EAGLE MOUNTAIN PLANNING COMMISSION MEETING

July 27, 2021, 5:30 PM

6.B PUBLIC HEARING - Stonebridge Montessori

**EAGLE MOUNTAIN CITY
PLANNING COMMISSION MEETING
JULY 27, 2021**

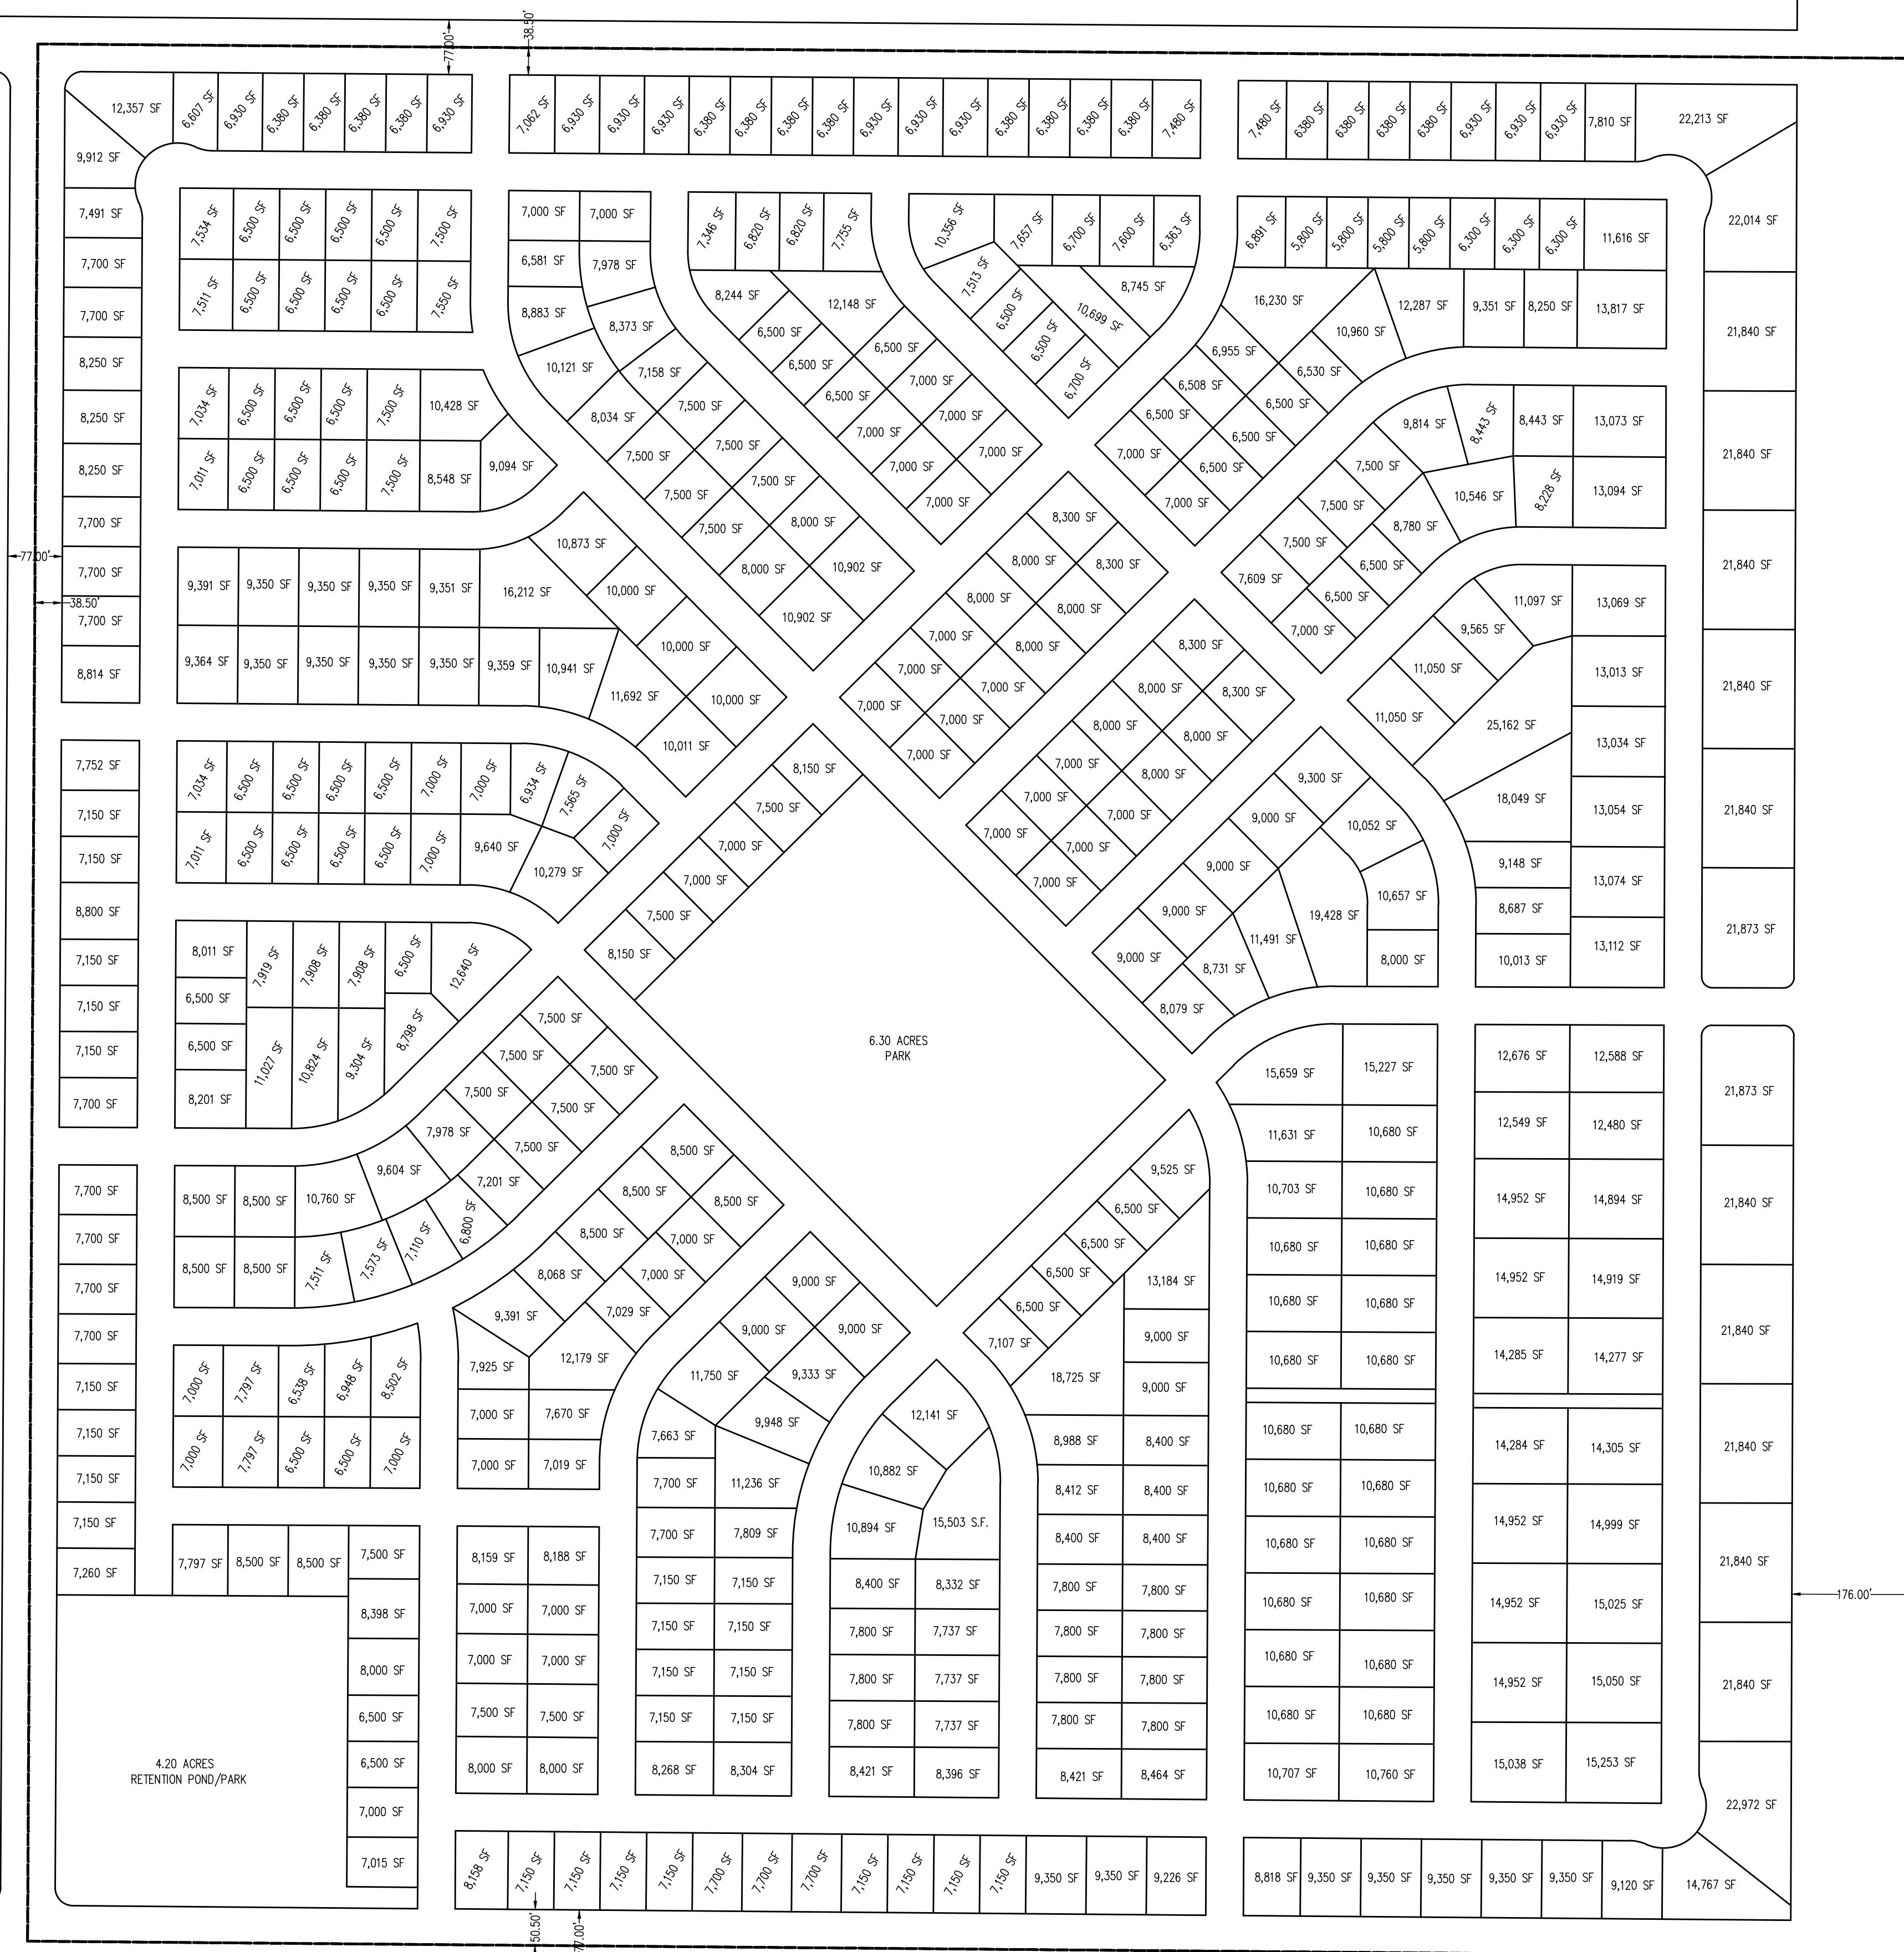
Staff also discussed moving the central park to the North-East for better spacing, but also to remove the straight thoroughfare through the project to provide traffic calming on residential streets, particularly those around the central park.

This concept will require a General Plan Amendment.

Staff advised the applicant that the roadways shown may need to be altered to comply with the locations shown on the Master Transportation Plan.

there was some concern expressed about the amount of MF zoning that is proposed in this concept.
